RE:	Project Name:	Alaska Department of Corrections, Juneau Central Office (JCO) Expansion
	Project Number:	230006085
	Project Location:	Juneau, Alaska
	New ITB Deadline:	August 25, 2023 @ 2:00 p.m. Alaska Time

Addendum # Two (2)

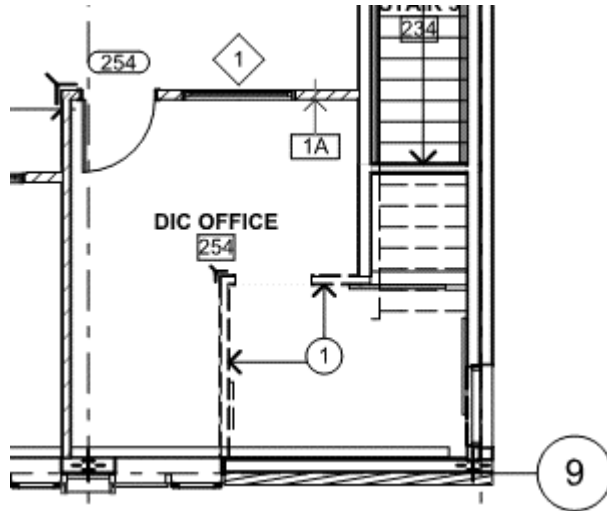
Q: A1.0: Existing office 254 does not appear on the demolition plan.

DOC Response: *Remove existing interior walls (approximately 16 lineal feet), door and frame located between grids 9 and 10, V and W, and all associated electrical devices that are not indicated on the demolition plans. Repair ceiling grid and replace partial ceiling tile as required. To complete new work. See sketch below.*
